**Work Plan for a  
Treatability Study in Support of the  
Intrinsic Remediation (Natural Attenuation) Option at  
Pumphouse 5 (Building 771)**

**Griffiss Air Force Base  
Rome, New York**

**June 1995**

Subject: Response to Comments on the "Intrinsic Remediation Treatability Study (TS) for Pumphouse 5", Griffiss AFB, New York.

**FIGURE 1.4**

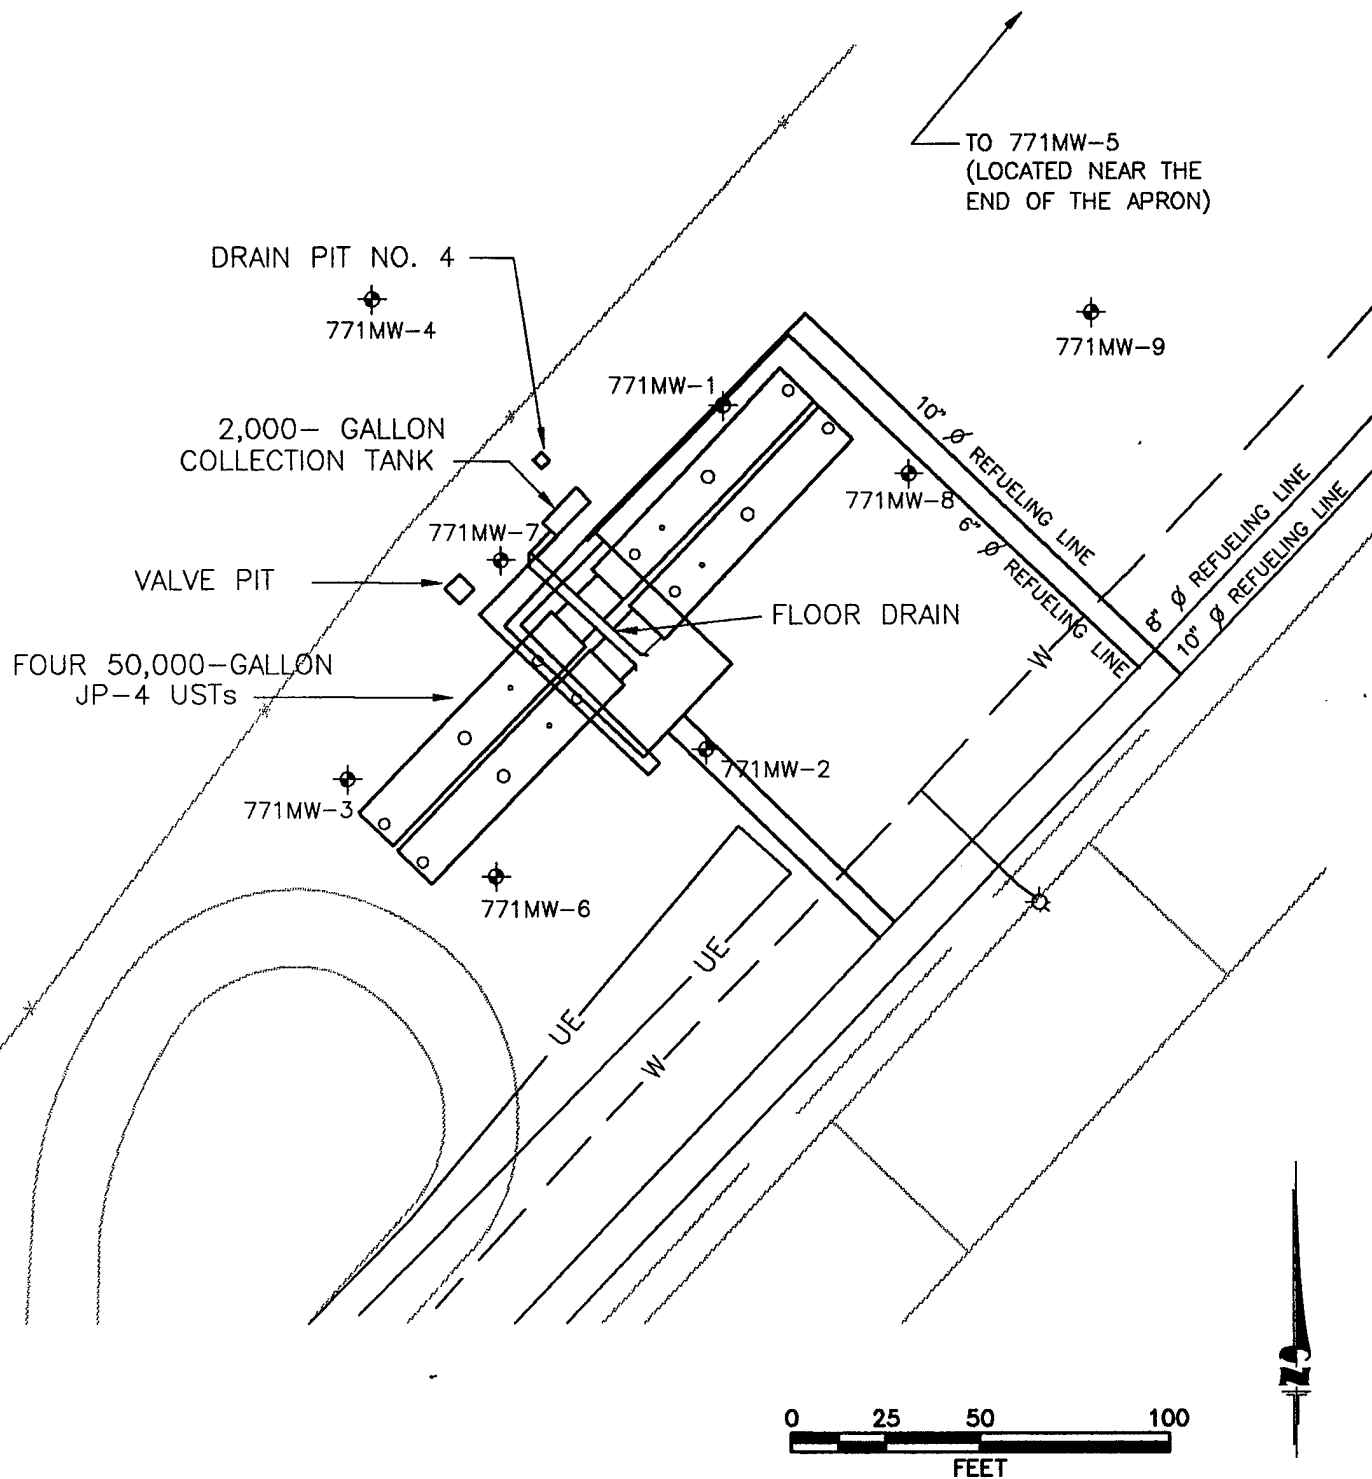
7. Please explain the use of the "valve pits." Also I would expect that piping would be connected to the valve pit; however, the diagrams (i.e., Figure 2-14) do not indicate that they are connected. Please clarify this issue.

**Response:** Agree, piping is connected to the valve pits; however, available diagrams used for this report do not indicate the location of piping connecting the USTs to the valve pits. Additional description on the use of valve pits has been included in the final paragraph on page 1-10 and reads (in bold):

"...response to precipitation or snowmelt filling the valve pit and clogging the valve system (Law, 1995). **The valve pits are used for isolation or diversion valves required for UST operation or for future expansion fuel storage operations.** Seasonally high groundwater elevations may also have pushed floating product from..."

**FIGURE 3.3**

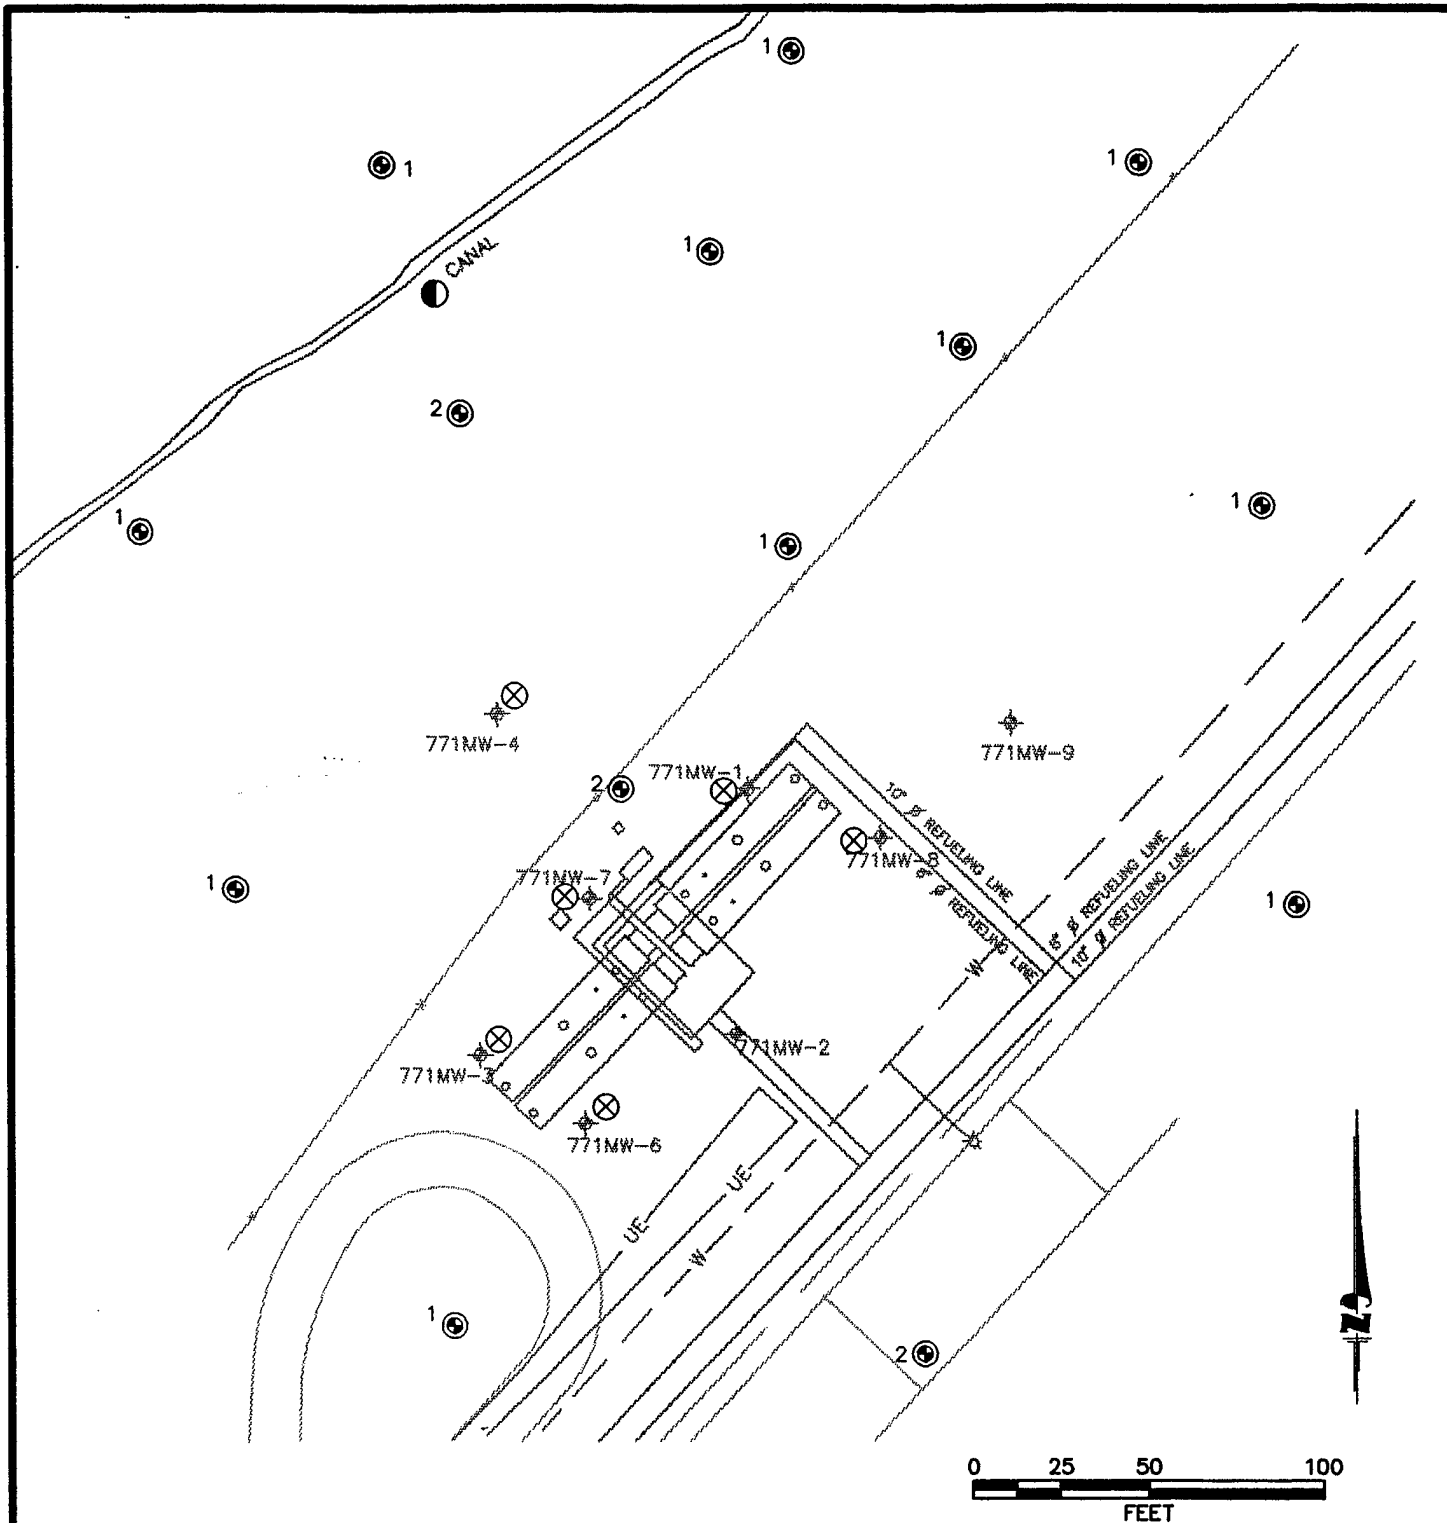
15. Sections 3.2.2.3.1 and 3.2.2.3.2: These sections discuss deep and shallow monitoring points, however, it is unclear from Figure 3.3 which are to be used and where. Please explain. Also, are well screens meant to straddle the water table?

16. Figure 3.3: I would like to see an additional sample point placed immediately north-northwest of monitoring well 771-MW4 (in between the two locations already depicted and in a direct line with the sample on the far side of Rainbow Creek).

**Response:** Figure 3.3 will be clarified to show the location of proposed deep and shallow monitoring points. Shallow monitoring points will be screened across the water table, while deep screen will be placed 8 to 10 feet below the water table.

**Response:** Additional sampling locations have been added to Figure 3.3 to satisfy your request for additional sampling points and to maintain a sampling line toward the creek.

FIGURE 2-10

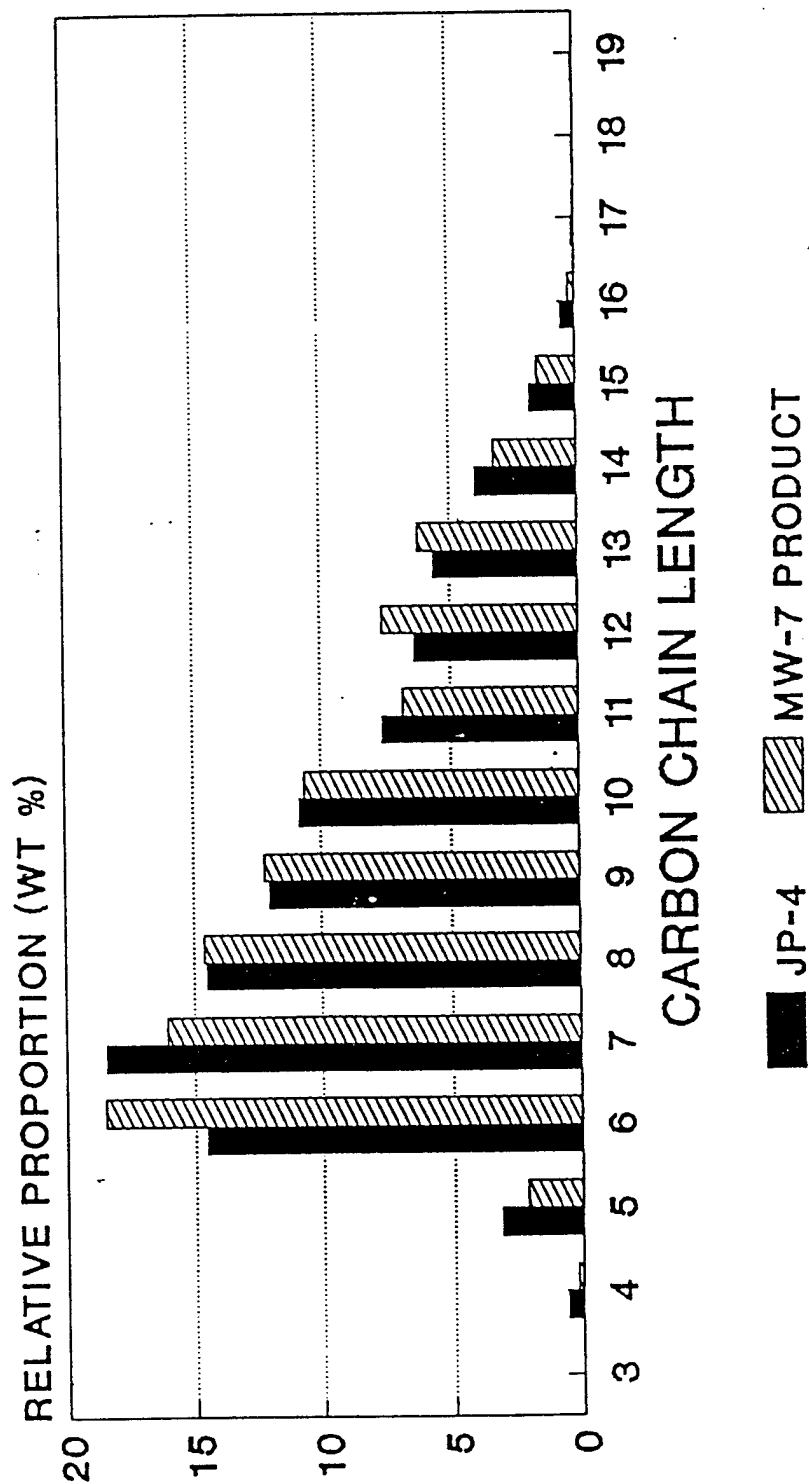
9. Page 2-22 (Section 2.1.3): The characterization of the analyzed petroleum as slightly weathered has been questioned by the NYSDEC in the past (see my November 16, 1994 comment letter; No. 11, attached). No acceptable response has been given.

**Response:** We agree that a total petroleum hydrocarbon scan (i.e., SW8015M) of the “weathered” fuel compared to a scan of “fresh” fuel is required to quantitate actual weathering of the fuel. However, the description in the last paragraph in Section 2.1.3 (Page 2-22) is a qualitative observation of fuel weathering based on observed losses of both low (C3 to C5) and high (C14-C19) molecular weight hydrocarbons. The statement was intended to inform the reader that relatively fresh fuels exist at the site, but have undergone slight environmental exposure.
